FSN - Field Safety Notice

R82, High-low:xo & Wombat Living

Devices included in this Field Safety Notice.

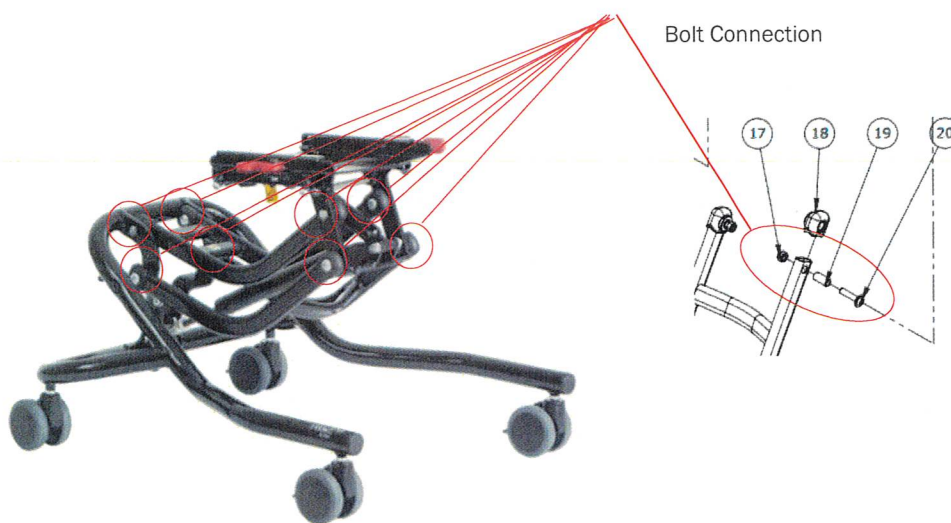
A low number of reports received from the market less than 0,12% of units sold indicates that a bolt or bolts in the bolt connections in the carry arms may not be sufficiently tightened and this can lead to a wobbly frame or broken bolt connection if bolts are not securely tightened. This can pose a risk for the device and the user.

An instruction to perform a retightening procedure of bolts and nuts in the bolt connections on the device. See below in red circles (8 places).

To mitigate this risk, we hereby recommend you perform a retightening of the bolts in the carry arms of the device. Please complete the following retightening procedure for all 8 bolt connections on the device (without the user in the device). Perform the retightening procedure before continuing to use the device or delivering it to your customers.
